# UNITED STATES PATENT AND TRADEMARK OFFICE

10/811,569

<b>Office Action Summary</b>	<b>Application No.</b> 10/811,569	<b>Applicant(s)</b> PULTE, WILLIAM J.	
	<b>Examiner</b> Adriana Figueroa	<b>Art Unit</b> 3637

## **DETAILED ACTION**

*Fig. 3.*

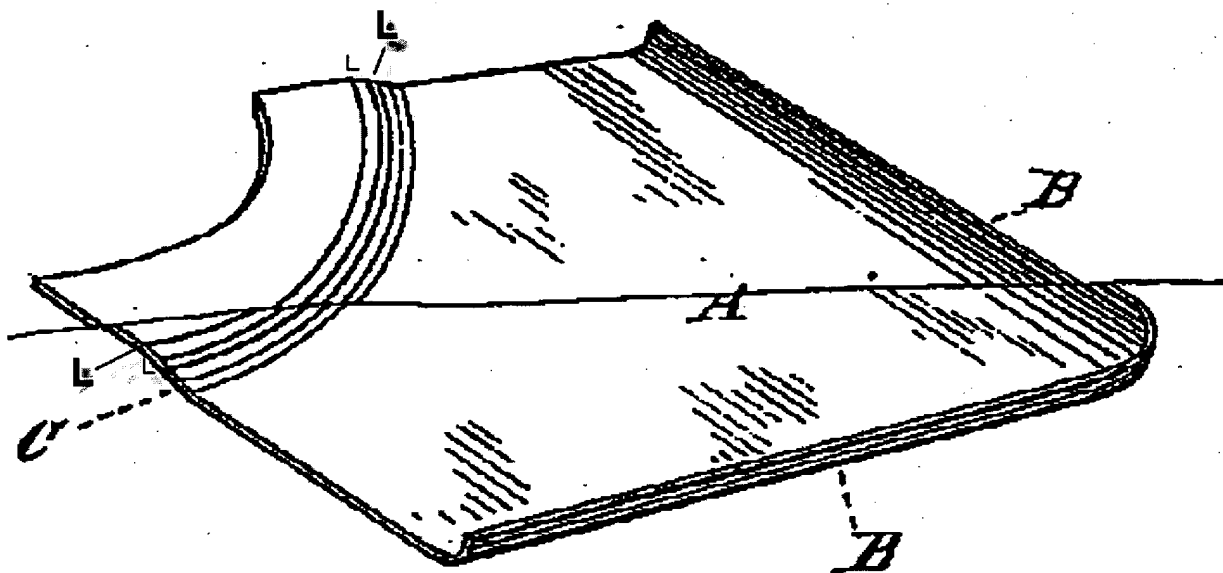
Regarding claim 1, Baker discloses a cap comprising a first surface (F); a second surface (S); and at least one stepped arcuate surface (c) intersecting said first surface and said second surface, (annotated Figure 1).

Regarding claim 2, Baker discloses a cap wherein said at least one stepped arcuate surface (c) consists of an "L" cross sections, (Figure 1, annotated Figure 3).

Regarding claim 3, Baker discloses a cap having a first edge (1) of said first surface, said second surface, and said at least one stepped arcuate surface; a second edge (2) of said first surface, said second surface, and said at least one stepped arcuate surface; a third edge (3) of said first surface; an arcuate surface (6) that intersects vertically with said third edge of said first surface; a fourth edge (4) of said second surface; and a fifth edge (5) of said second surface, (annotated Figure 1).

Regarding claim 7, Baker discloses a cap having a plurality of stepped arcuate surfaces (c), (Figures 1, 3).

Regarding claim 8, Baker discloses a cap wherein said plurality of stepped arcuate surfaces (c) consists of "L" cross sections, (Figure 1, annotated Figure 3).

Regarding claim 11, Baker discloses a cap comprising a first surface (F); a second surface (S); and at least one stepped arcuate surface (c) intersecting said first surface and said second surface; a first edge (1) of said first surface, said second surface, and said at least one stepped arcuate surface; a second edge (2) of said first surface, said second surface, and said at least one stepped arcuate surface; a third edge (3) of said first surface; an arcuate surface (6) that intersects vertically with said third edge of said first surface; a fourth edge (4) of said second surface; and a fifth edge (5) of said second surface, (annotated Figure 1).

Regarding claim 12, Baker discloses a cap wherein said at least one stepped arcuate surface (c) consists of an "L" cross sections, (Figure 1, annotated Figure 3).

Regarding claim 16, Baker discloses a cap having a plurality of stepped arcuate surfaces (c), (Figures 1, 3).

Regarding claim 17, Baker discloses a cap wherein said plurality of stepped arcuate surfaces (c) consists of “L” cross sections, (Figures 1, annotated Figure 3).
